PROPOSAL FOR DRAFT AMENDMENT TO REGULATION No.44
TRANSMITTED BY EXPERT FROM JAPAN

A. PROPOSAL

Annex 7 - *Appendix 2-1*

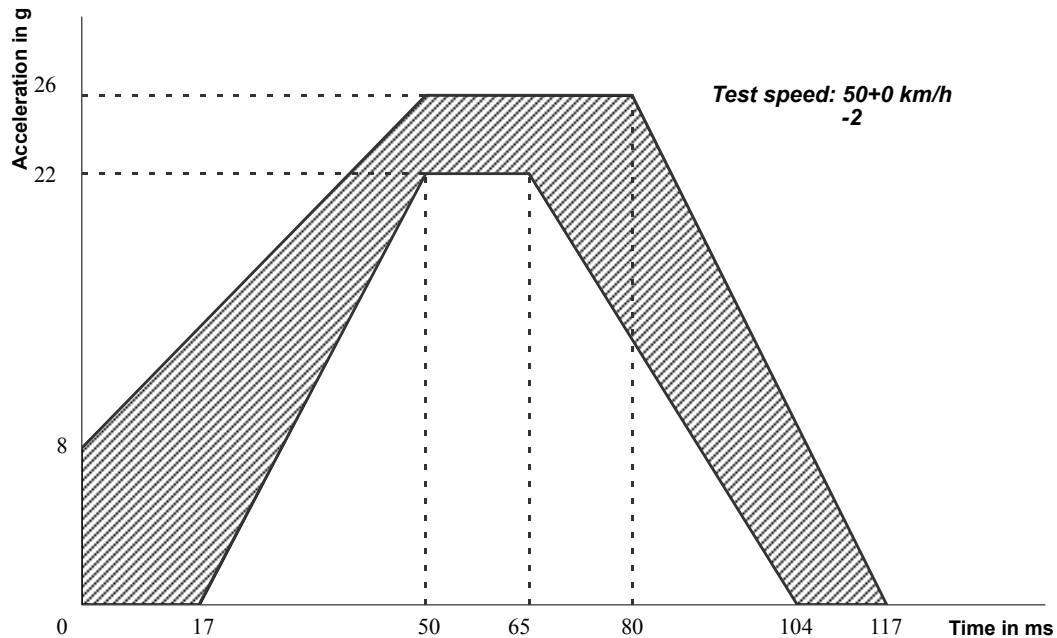
Insert new Appendix 2-1., to read

Curves of the trolley's acceleration as a function of time

Frontal impact

[Modification of corridor ($\pm 4G \rightarrow \pm 2G$ for acceleration device)]

Corridor shown in annex 7 appendix 2-1 to this regulation has smaller limits comparing with existing corridor of deceleration device.

The new corridor has width of $\pm 2G$ from the centre line while existing corridor has one of $\pm 4G$. Timing of inflection point and slope are set the same in both corridors.

Annex 7 - *Appendix 2-2*

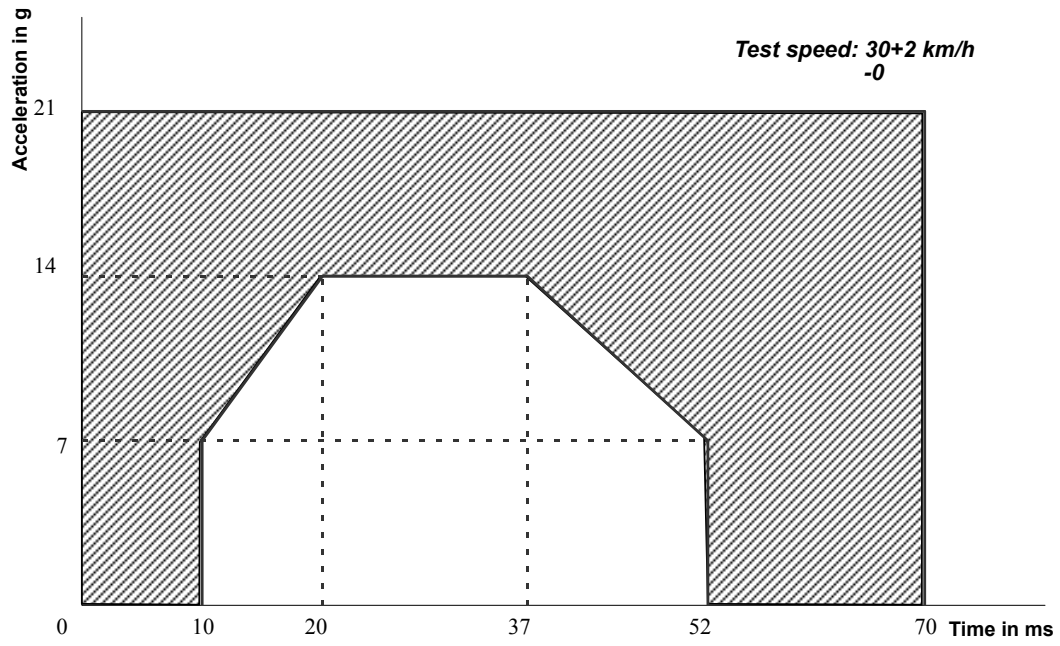
Insert new Appendix 2-2., to read

Curves of the trolley's acceleration as a function of time

Rear impact
